Access Compliance Report

Public Rights-of-Way

(Curb Ramps)

Intersection ID: 11349	Main Street: N_DAVIDSON_ST	Cross Street: PARKWOOD_AV	Location: W
ADA ID: 5F80F32FEB6F	Ramp Type: Perp	Initial Pass/Fail: Fail	Overall Compliance: No
Severity Score: 21.25			
Codes/Mitigation Info/Possible Solution		Field Measurements/Component Compliance

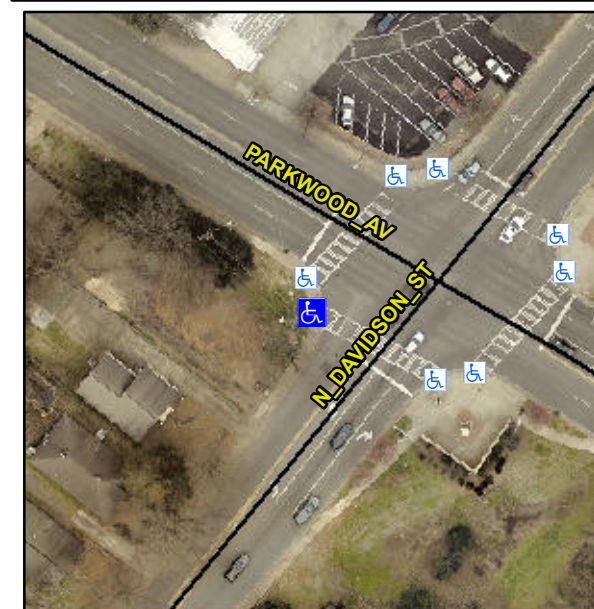
Not Found, R304.5.1, R304.2.2

Compliance	Description	Data	Compliance	Description	Data
N/A	Ramp Length (in)	59.5	No	Ramp Slope (%)	9.7
No	Ramp Width (in)	46.5	Yes	Ramp XSlope (%)	1.8
N/A	Flare Type LT	N/A	N/A	Flare Type RT	N/A
N/A	Flare Slope LT (%)	N/A	N/A	Flare Slope RT (%)	N/A
N/A	Flare Traversable LT?	N/A	N/A	Flare Traversable RT?	N/A
N/A	Landing Length (in)	N/A	N/A	DWS Provided?	N/A
N/A	Landing Width (in)	N/A	N/A	DWS Contrast?	N/A
N/A	Landing Slope (%)	N/A	N/A	DWS Length (in)	N/A
N/A	Landing X Slope (%)	N/A	N/A	DWS Full Width?	N/A
N/A	Landing Curb? (Y/N)	N/A	N/A	DWS Offset (in)	N/A
N/A	Shared Landing?	N/A			
N/A	Gutter Ponding?	N/A	N/A	Gutter Slope (%)	N/A
N/A	Gutter Lip Ht (in)	N/A	N/A	Gutter X Slope (%)	N/A
N/A	Painted X Walk1?	Yes	N/A	Painted X Walk2?	N/A
	X Walk 1 Direction	To SE		X Walk 2 Direction	N/A
N/A	X Walk 1 Width (in)	110.0	N/A	X Walk 2 Width (in)	N/A
	X Walk 1 Slope (%)	2.8		X Walk 2 Slope (%)	N/A
	X Walk 1 X Slope (%)	2.3		X Walk 2 X Slope (%)	N/A

Remove & Replace Entire Ramp.
